FRAV: (In-)vehicle interaction safety requirements & ADS

SRs with respect to in-vehicle HMI

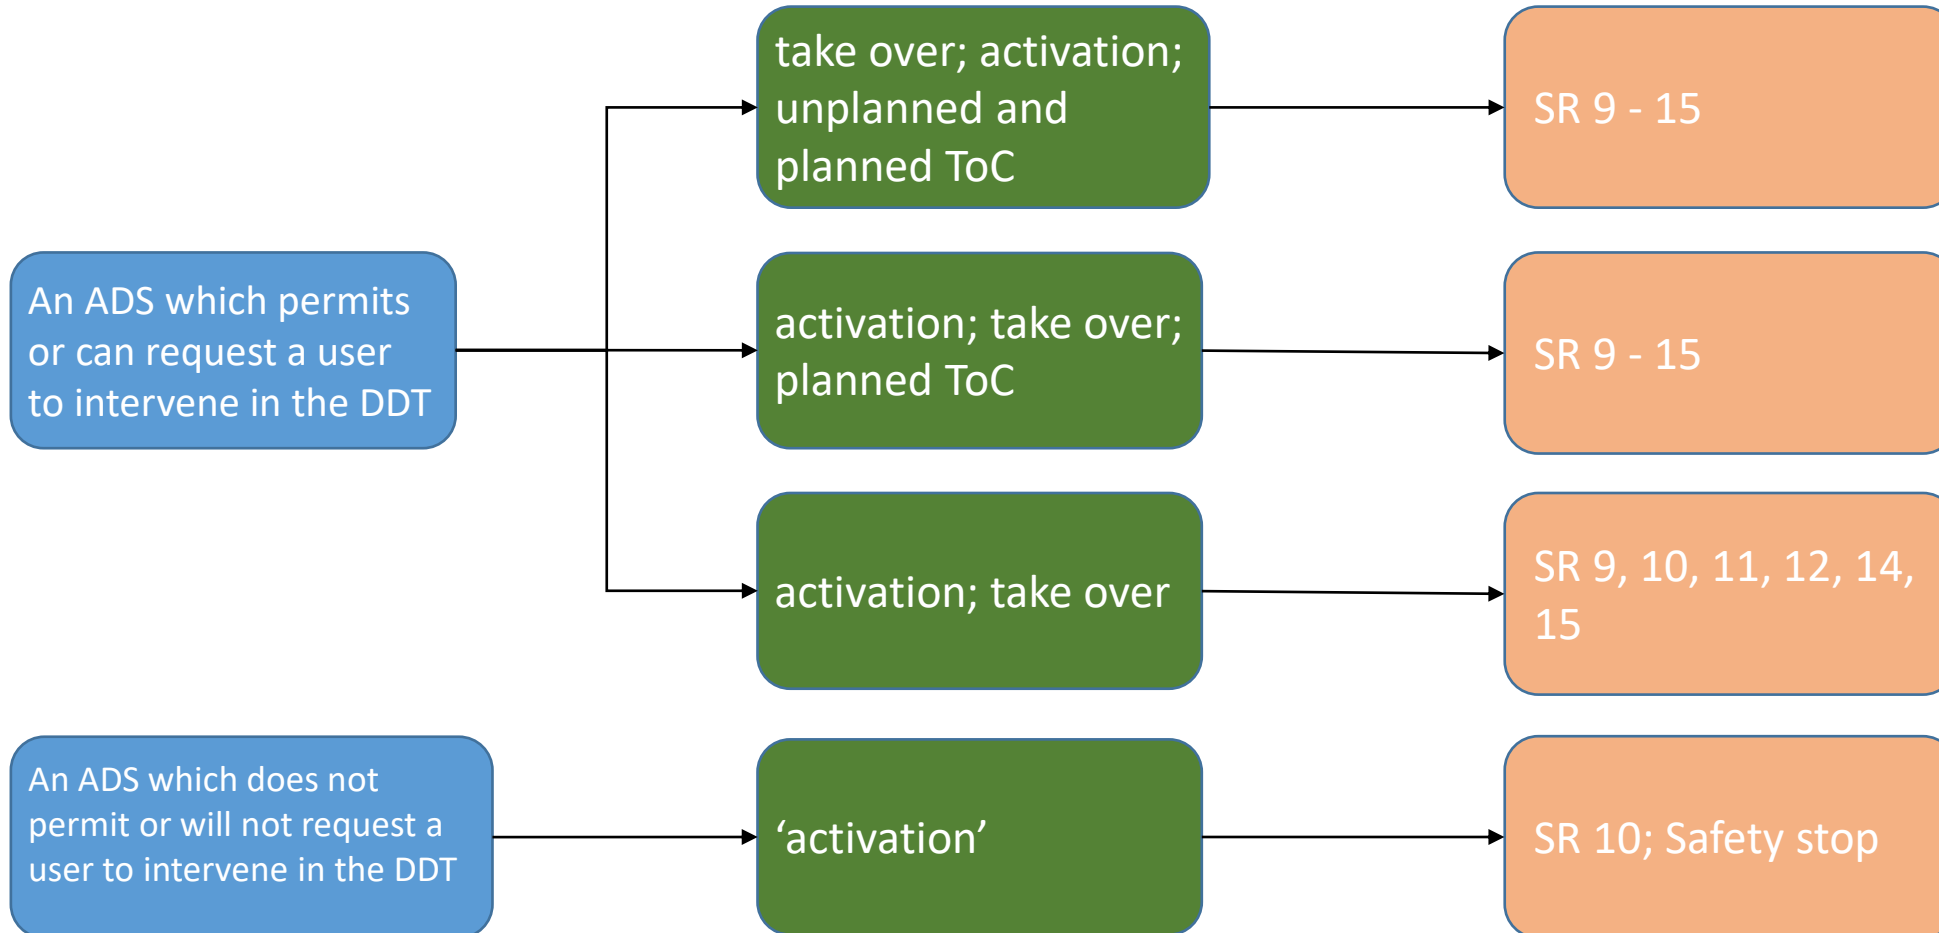
- HMI to and for maintenance personnel and remote operations are not considered yet. Such an HMI can be considerably affected by the use case and also serves a different purpose.
- Is this the way we want to show which SR applies to which ADS use case?
